Appendix F: Facility Reports

Casa House - Exterior
40 West Olive Street, Madera

Engineering Annex - Exterior & First Floor
205 West 4th Street, Madera

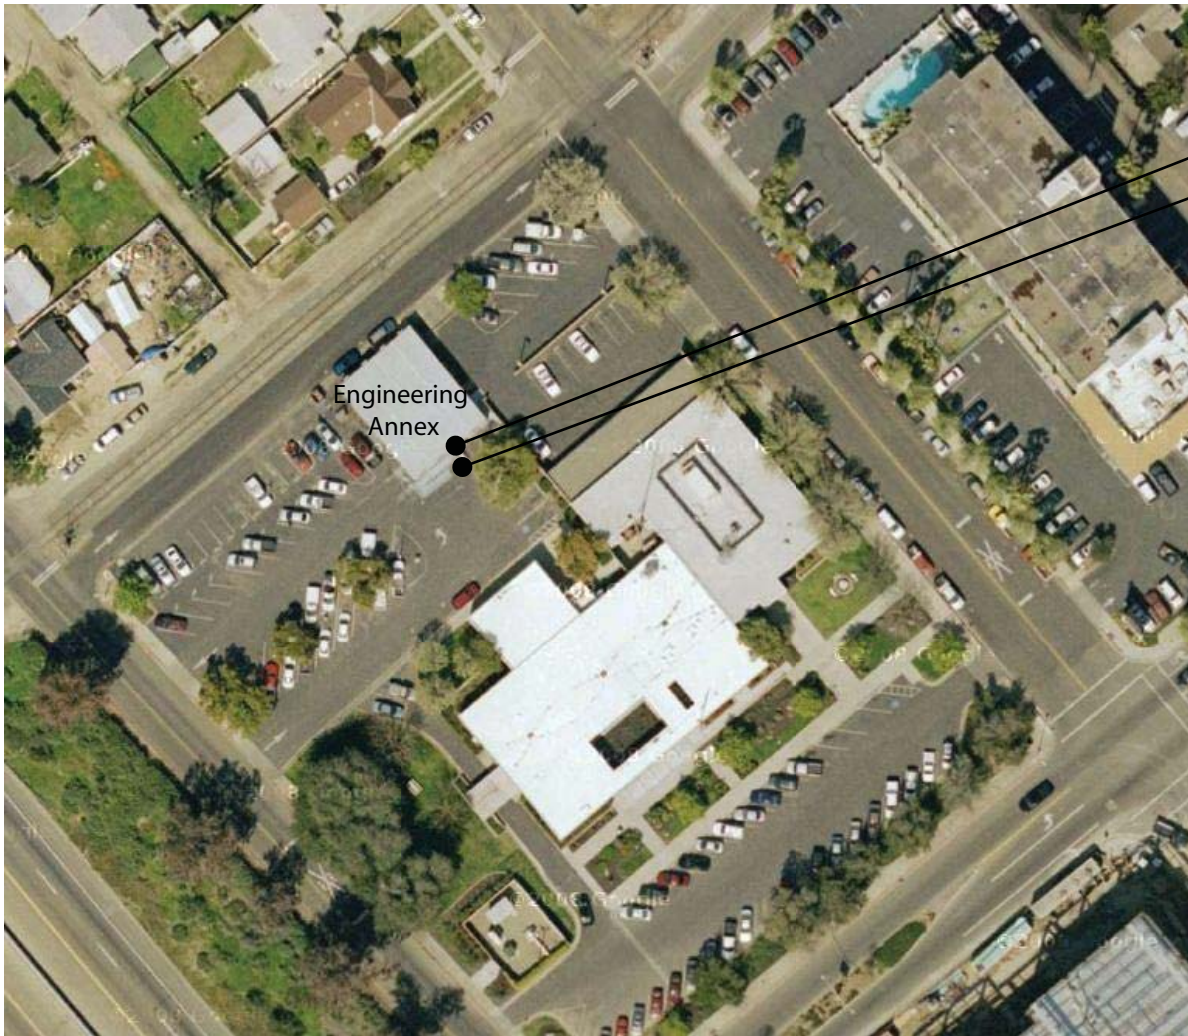
Floor 1		
8 - 1	Door/Gate	Priority: 1
Adjust door closer		\$100
Notes: Operating effort is 9 lbs (5 lbs max).		
State: 1133B.2.5		
Federal: 4.13.11		
Install or modify permanent room signs		\$250
Notes: There is an exit sign but Braille is not provided.		
State: 1011.3 #3		
Federal: -		
Provide sign(s) indicating accessible entries and facilities		\$100
Notes: Accessible entry is not marked by the International Symbol of Accessibility.		
State: 1117B.5.8.1.2, 1127B.3		
Federal: 4.13.6		
Enlarge door opening		\$3,500
Notes: Height of clear opening is 78.5" (80" min) to door closer.		
State: 1008.11, 1133B.2.2		
Federal: 4.4.2

Fire Station #6 - Exterior & First Floor
317 Lake Street, Madera

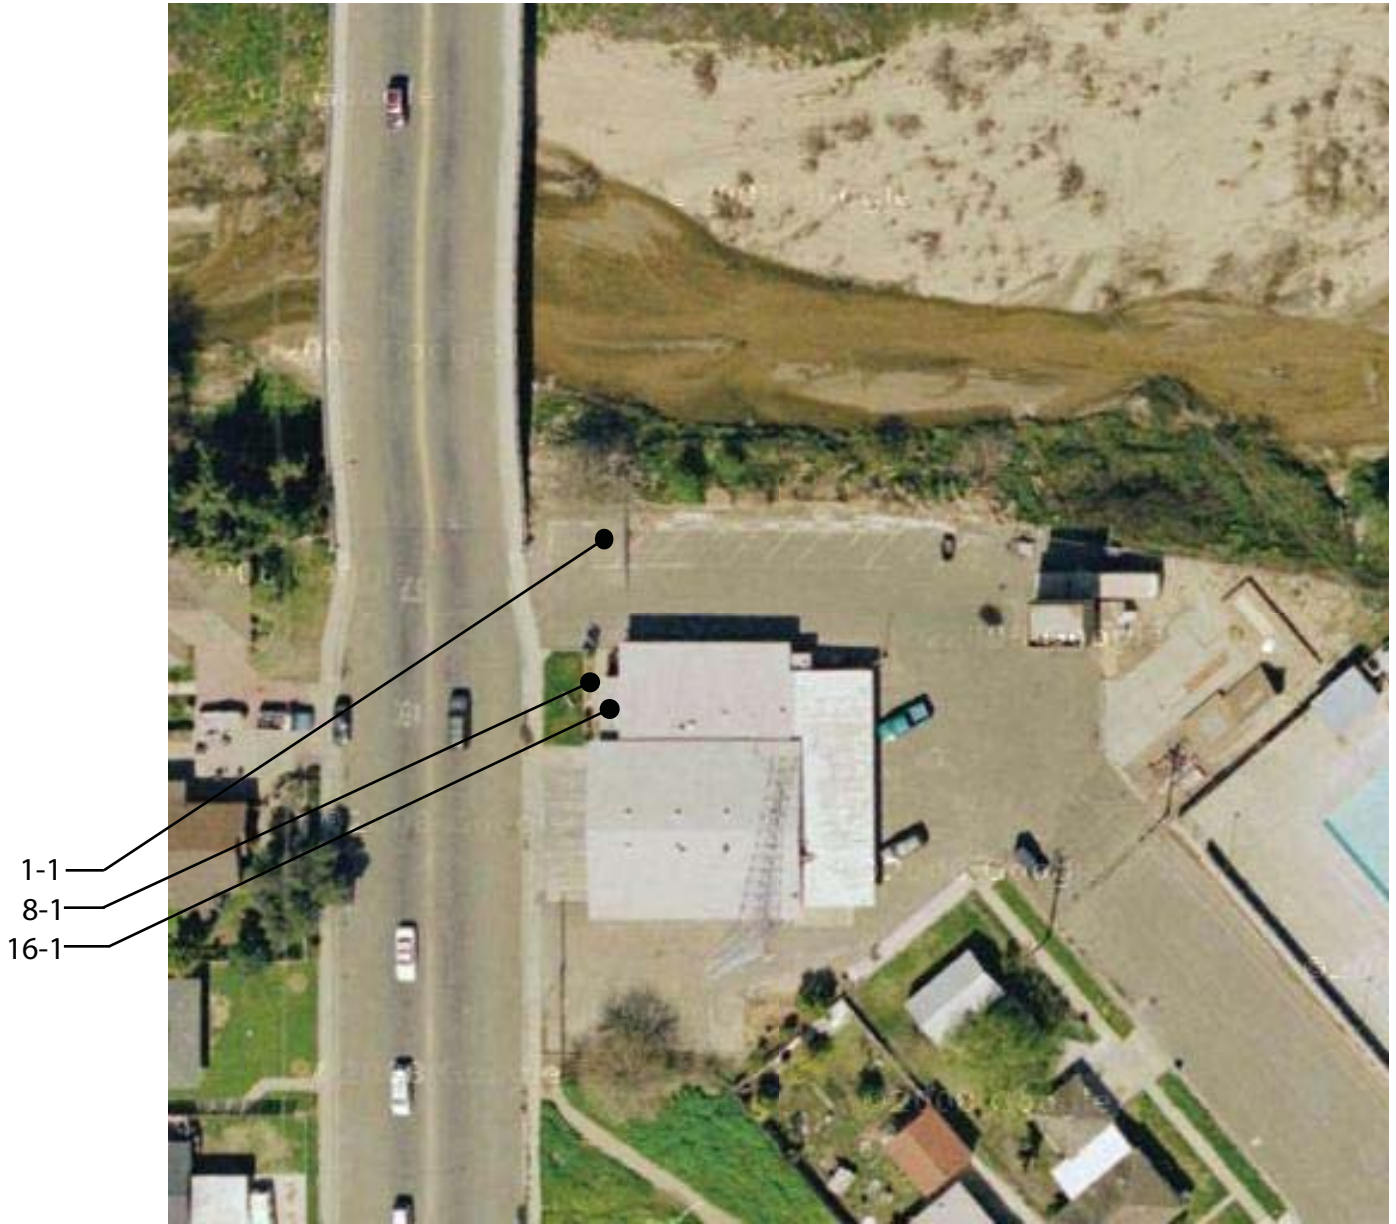
Exterior		
1 - 1	Parking Area	Priority: 1
Provide or modify accessible spaces		\$2,950
Notes: Accessible parking spaces are not provided. Provide an accessible parking space.		
State: 1129B		
Federal: 4.1.2(5)(b)

Floor 1		
8 - 1	Door/Gate	Priority: 1
Provide an accessible path of travel		\$2,000
Notes: Accessible route to the door is not provided due to a step located on path of travel.		
State: 1133B.1.1.1.1		
Federal: 4.3.2		
Adjust door closer		\$100
Notes: Operating effort is 10 lbs (5 lbs max).		
State: 1133B.2.5		
Federal: 4.13.11		
Provide sign(s) indicating accessible entries and facilities		\$100
Notes: Primary entrance is not marked by an International Symbol of Accessibility.		
State: 1117B.5.8.1.2, 1127B.3		
Federal: 4.13.6		
Provide or modify door kickplate		\$100
Notes: Kickplate is 4.5" (10" min) high.		
State: 1133B.2.6		
Federal: -		
16 - 1	Transaction Counter	Priority: 2
Provide an accessible counter		\$4,000
Notes: Transaction counter is 42" (28" to 34") AFF.		
State: 1122B.5		
Federal: 4.32.4

Frank Bergon Senior Center - Exterior
238 South D Street, Madera

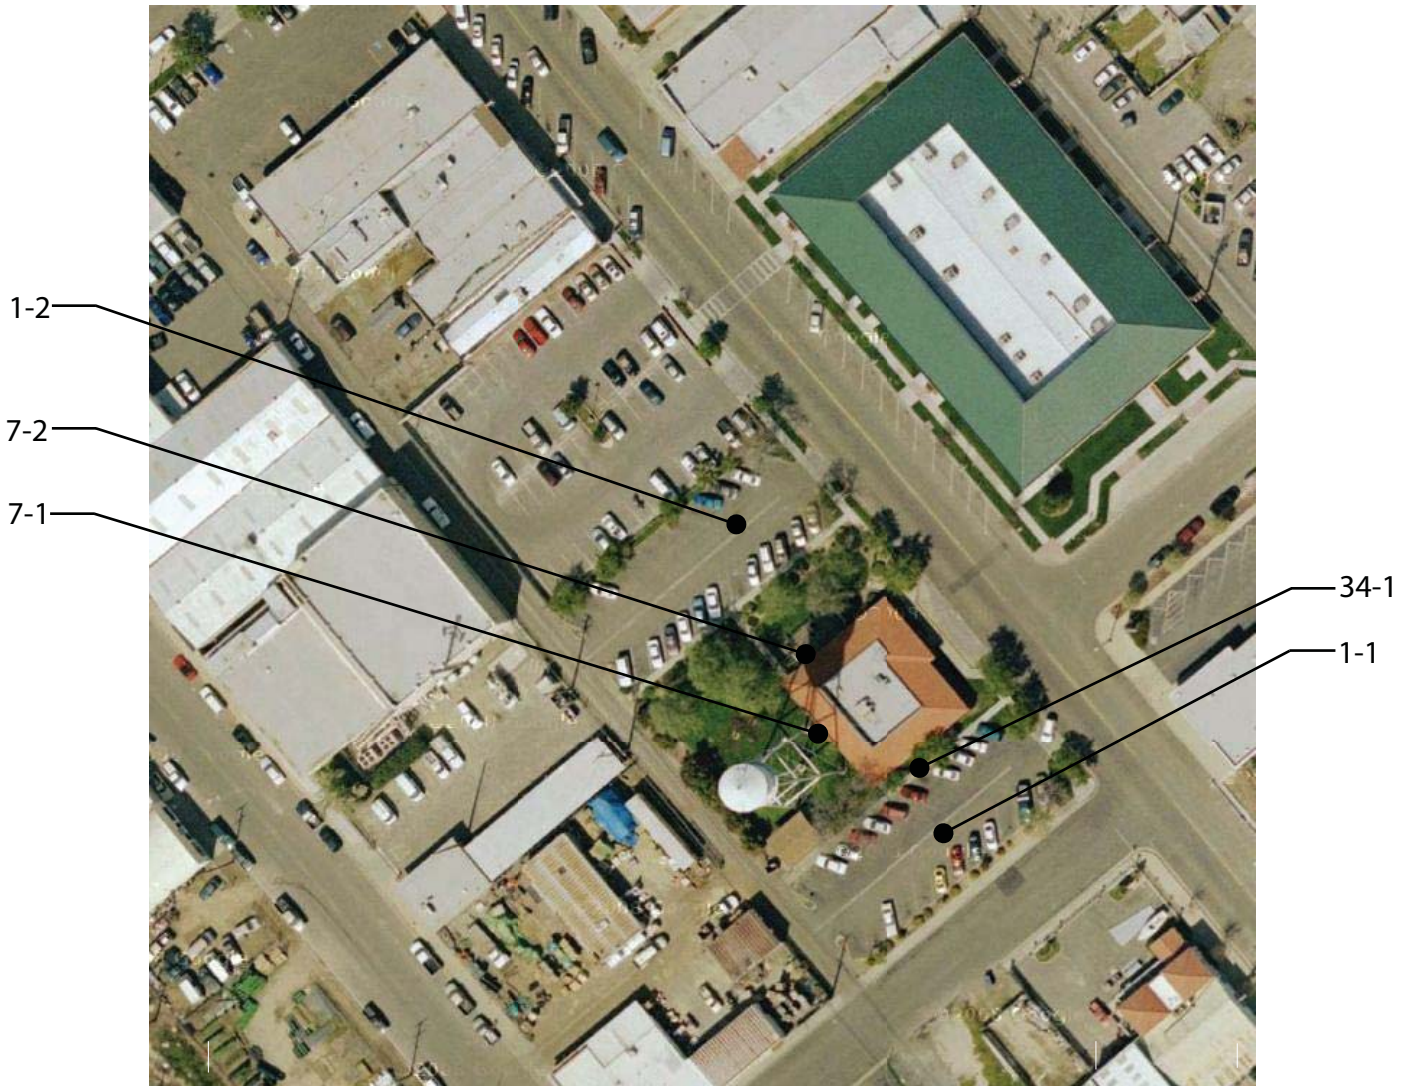
Exterior		
1 - 1	Parking Area	Priority: 1
Install sign		\$50
Notes: The words 'NO PARKING' are not painted in the access aisle.		
State: 1129B.3 #1, 1129B.3 #2		
Federal: -		
Install van parking sign		\$250
Notes: Reflectorized signage indicating accessible parking space is not provided. Provide signage that is van accessible.		
State: 1129B.4		
Federal: 4.6.4		
Install sign for unauthorized parking		\$400
Notes: Tow-away sign does not provide contact information. Provide tow-away sign with contact information.		
State: 1129B.4, 1133B.8.6.3		
Federal: -		
Regrade surface		\$1,800
Notes: Slope in the access aisle is 21.8% (2% max) due to built-up curb ramp.		
State: 1129B.3 #4		
Federal: 4.6.3		
Provide or modify accessible access aisles		\$150
Notes: Access aisle is 55" (96" min for van accessible space). Access aisle does not have blue border.		
State: 1129B.3 #1, 1129B.3 #2, 1129B.4 #1		
Federal: 4.6.3		
Install sign		\$100

Exterior		
1 - 2	Parking Area	Priority: 1
Install sign		\$50
Notes: The words 'NO PARKING' are not painted in the access aisle.		
State: 1129B.3 #1, 1129B.3 #2		
Federal: -		
Install van parking sign		\$250
Notes: Reflectorized signage indicating accessible parking space is not provided. Provide signage that is van accessible.		
State: 1129B.4		
Federal: 4.6.4		
Install sign for unauthorized parking		\$400
Notes: Tow-away sign not provided.		
State: 1129B.4, 1133B.8.6.3		
Federal: -		
Regrade surface		\$1,800
Notes: Slope in the access aisle is 17% (2% max) due to built-up curb ramp.		
State: 1129B.3 #4		
Federal: 4.6.3		
Provide or modify accessible access aisles		\$150
Notes: Access aisle is 60" (96" min for van accessible space). Access aisle does not have blue border.		
State: 1129B.3 #1, 1129B.3 #2, 1129B.4 #1		
Federal: 4.6.3		
Install sign		\$100
Notes: Additional sign stating "Minimum Fine \$250" not provided at the 1 accessible space.

State: 1129B.4		
Federal: -		
Provide or modify accessible spaces		\$2,550
Notes: There are a total of 26 parking spaces and 1 accessible parking space. 2 accessible parking spaces are required. Provide 1 additional accessible parking space.		
State: 1129B		
Federal: 4.1.2(5)(b)

Exterior		
7 - 1	Hazard	Priority: 4
Remove overhanging or protruding objects		\$100
Notes:	Light fixture protrudes 11.5" (4" max) and is 66.5" (not between 27" to 80") AFF on the path of travel to the primary entrance of the Senior Center. Provide something below the light fixture that is cane-detectable.	
State:	1133B.8.6.1	
Federal:	4.4.1	
7 - 2	Hazard	Priority: 4
Remove overhanging or protruding objects		\$100
Notes:	Light fixture protrudes 11.5" (4" max) and is 66.5" (not between 27" to 80") AFF on the path of travel to the primary entrance of the Senior Center. Provide something below the light fixture that is cane-detectable.	
State:	1133B.8.6.1	
Federal:	4.4.1	
34 - 1	Fixed Bench	Priority: 4
Increase or provide maneuvering or clear floor area		\$800
Notes:	30" x 48" min. companion seating are not provided at either ends of the bench pads.	
State:	-	
Federal:	-	
Provide accessible fixed bench		\$900

Frank Bergon Senior Center - First Floor
238 South D Street, Madera

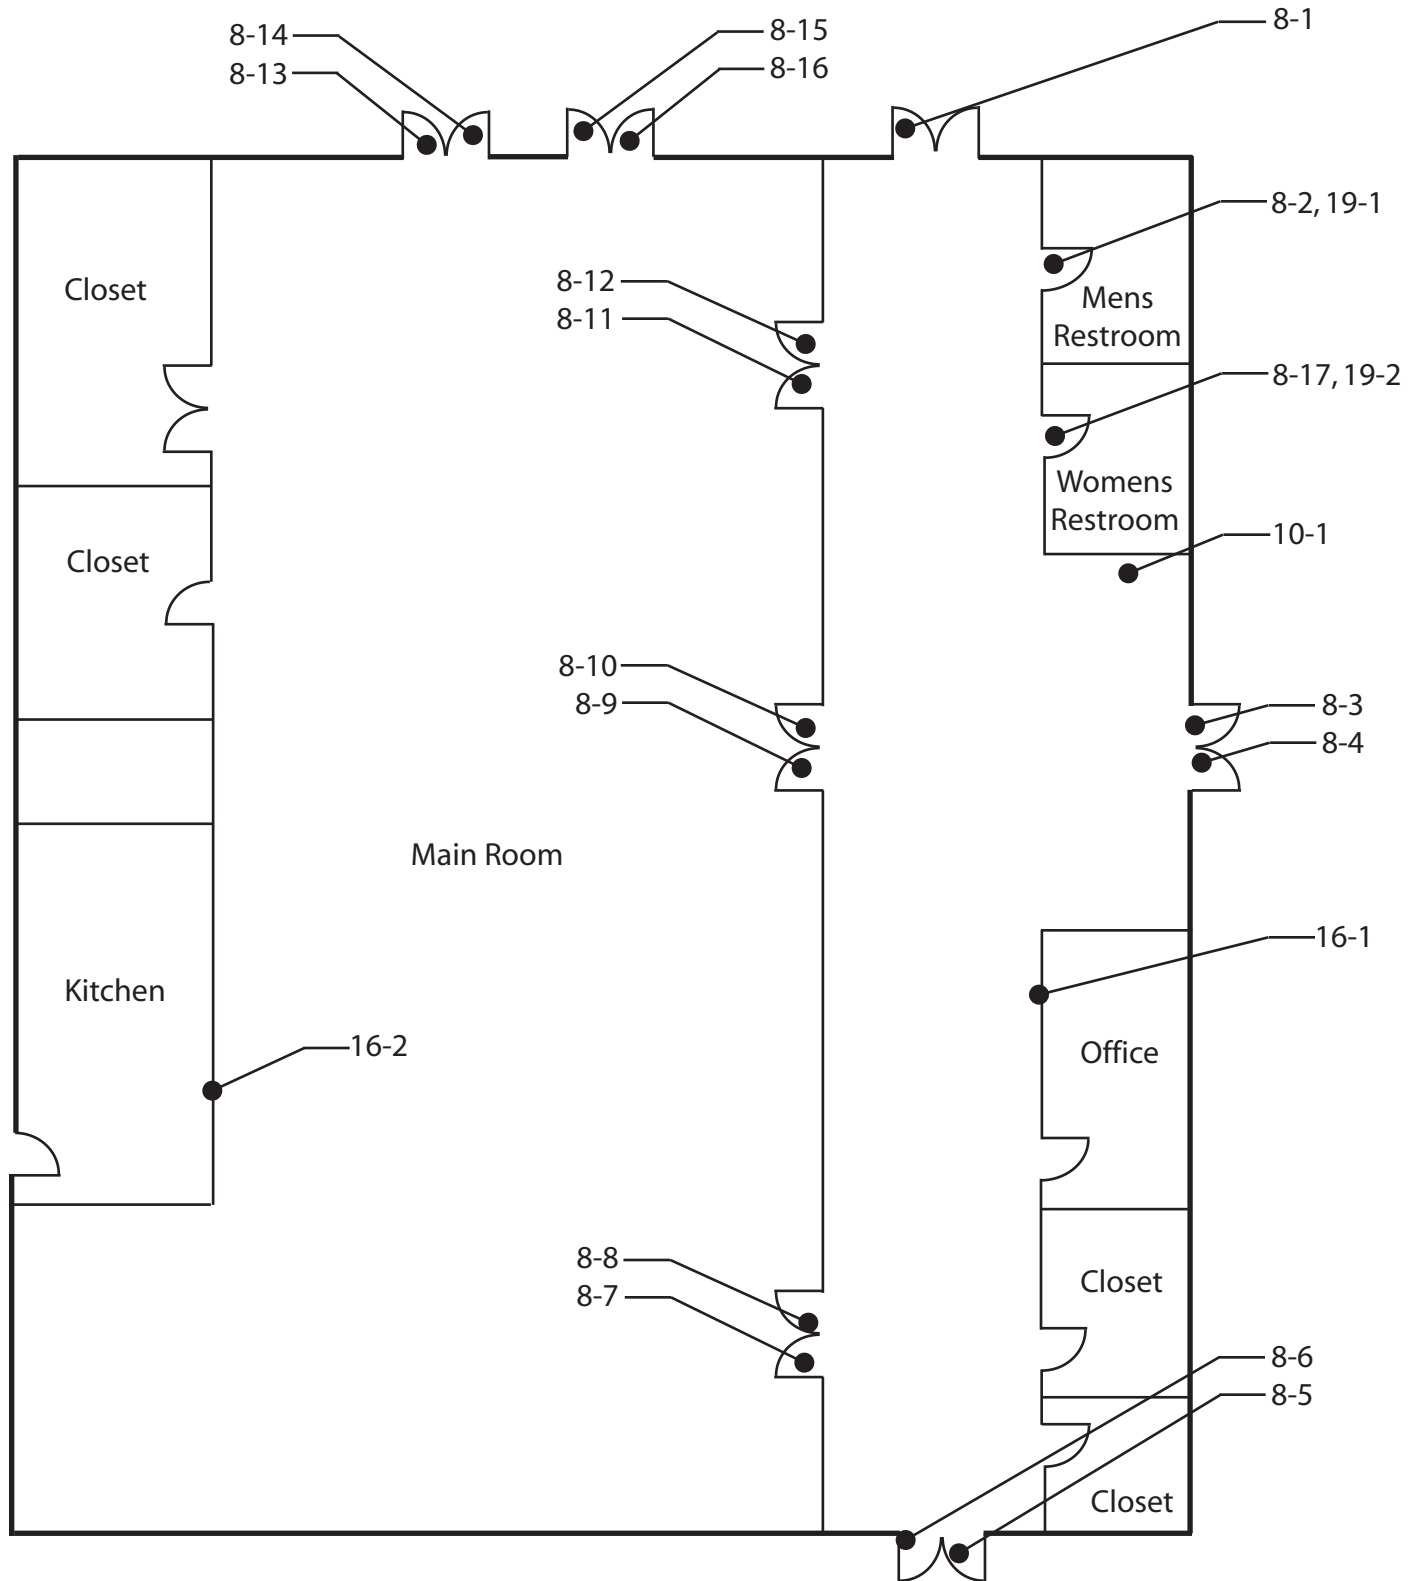
Floor 1		
8 - 1	Door/Gate	Priority: 1
Install or modify permanent room signs		\$250
Notes: There is an exit sign but Braille is not provided.		
State: 1011.3 #3		
Federal: -		
8 - 2	Door/Gate	Priority: 2
Adjust door closer		\$100
Notes: Operating effort is 6 lbs (5 lbs max).		
State: 1133B.2.5		
Federal: 4.13.11		
Provide additional strike edge clearance		\$3,000
Notes: Strike-edge clearance on swing-side is 3" (18" min).		
State: 1133B.2.4.3		
Federal: 4.13.6		
8 - 3	Door/Gate	Priority: 1
Install or modify permanent room signs		\$250
Notes: There is an exit sign but Braille is not provided.		
State: 1011.3 #3		
Federal: -		
Adjust door closer		\$100
Notes: Operating effort is 10 lbs (5 lbs max).		
State: 1133B.2.5		
Federal: 4.13.11		
8 - 4	Door/Gate	Priority: 1
Adjust door closer		\$100
Notes: Operating effort is 11 lbs (5 lbs max).		
State: 1133B.2.5		
Federal: 4.13.11		
8 - 5	Door/Gate	Priority: 1
Install or modify permanent room signs		\$250

Floor 1		
8 - 6	Door/Gate	Priority: 1
Adjust door closer		\$100
Notes: Operating effort is 11 lbs (5 lbs max).		
State: 1133B.2.5		
Federal: 4.13.11		
8 - 7	Door/Gate	Priority: 4
Provide or modify door kickplate		\$100
Notes: Doorstop mounted on kickplate, however doors remain open during business hours.		
State: 1133B.2.6		
Federal: -		
8 - 8	Door/Gate	Priority: 4
Install or modify permanent room signs		\$250
Notes: There is an exit sign but Braille is not provided.		
State: 1011.3 #3		
Federal: -		
Provide or modify door kickplate		\$100
Notes: Doorstop mounted on kickplate, however doors remain open during business hours.		
State: 1133B.2.6		
Federal: -		
8 - 9	Door/Gate	Priority: 4
Install or modify permanent room signs		\$250
Notes: There is an exit sign but Braille is not provided.		
State: 1011.3 #3		
Federal: -		
Provide or modify door kickplate		\$100
Notes: Doorstop mounted on kickplate, however doors remain open during business hours.

Floor 1		
8 - 11	Door/Gate	Priority: 4
Install or modify permanent room signs		\$250
Notes: There is an exit sign but Braille is not provided.		
State: 1011.3 #3		
Federal: -		
Provide or modify door kickplate		\$100
Notes: Doorstop mounted on kickplate, however doors remain open during business hours.		
State: 1133B.2.6		
Federal: -		
8 - 12	Door/Gate	Priority: 4
Provide or modify door kickplate		\$100
Notes: Doorstop mounted on kickplate, however doors remain open during business hours.		
State: 1133B.2.6		
Federal: -		
8 - 13	Door/Gate	Priority: 1
Install or modify permanent room signs		\$250
Notes: There is an exit sign but Braille is not provided.		
State: 1011.3 #3		
Federal: -		
Adjust door closer		\$100
Notes: Operating effort is 12 lbs (5 lbs max).		
State: 1133B.2.5		
Federal: 4.13.11		
8 - 14	Door/Gate	Priority: 1
Adjust door closer		\$100
Notes: Operating effort is 12 lbs (5 lbs max).		
State: 1133B.2.5

Floor 1		
8 - 16	Door/Gate	Priority: 1
Adjust door closer		\$100
Notes: Operating effort is 22 lbs (5 lbs max).		
State: 1133B.2.5		
Federal: 4.13.11		
8 - 17	Door/Gate	Priority: 2
Adjust door closer		\$100
Notes: Operating effort is 10 lbs (5 lbs max).		
State: 1133B.2.5		
Federal: 4.13.11		
Provide additional strike edge clearance		\$3,000
Notes: Strike-edge clearance on swing-side is 3.5" (18" min).		
State: 1133B.2.4.3		
Federal: 4.13.6		
10 - 1	Drinking Fountain	Priority: 3
Provide wing walls or textured floor surface		\$750
Notes: Drinking fountain is not located in an alcove. Provide wing walls.		
State: 1115B.4.6 #3		
Federal: 4.15.5		
Replace or reposition drinking fountain		\$3,500
Notes: Hi-low fountain not provided. Bubbler height is 42" (36" max) AFF. Knee height is 22" (27" min). Depth is 12.5" (18" to 19").		
State: 1115B.4.6 #1, 1115B.4.6 #2, 1115B.4.6 #4, 1117B.4.6 #2		
Federal: 4.1.6, 4.15.2, 4.15.5

16 - 1	Transaction Counter	Priority: 2
Provide an accessible counter		\$4,000
Notes: Transaction counter is 38" (28" to 34") AFF.		
State: 1122B.5		
Federal: 4.32.4		
16 - 2	Transaction Counter	Priority: 2
Provide an accessible counter		\$4,000
Notes: Kitchen counter is 36.25" (28" to 34") AFF.		
State: 1122B.5		
Federal: 4.32.4

Floor 1		
19 - 1	Multiple User Restroom	Priority: 2
Install sign		\$100
Notes: California required signage is centered 62" (60" absolute) AFF. Lower signage.		
State: 1115B.6		
Federal: 4.30.4		
Install sign		\$250
Notes: Federal required signage is not provided on the latch side of the door. ISA not provided.		
State: 1115B.6, 1117B.5.1 #1, 1117B.5.5 #3, 1117B.5.8.1.2		
Federal: 4.30.4		
Increase or provide maneuvering or clear floor area		\$2,500
Notes: Clear space to the urinal is 29.5" (44" min).		
State: 1115B.3.1 #4.5		
Federal: 4.17.1		
Modify lavatory/counter clearances		\$3,500
Notes: Height of lavatory is 36.5" (34" max) AFF. Lower lavatory.		
State: 1115B.4.3 #2		
Federal: 4.19.2		
Insulate water lines		\$100
Notes: Hot water pipe not insulated.		
State: 1115B.4.3 #4		
Federal: 4.19.4		
Replace or reposition urinal		\$1,500
Notes: Urinal is 24.75" (17" max) from the floor to the lip. Flush control is 51.5" (44" max) AFF.
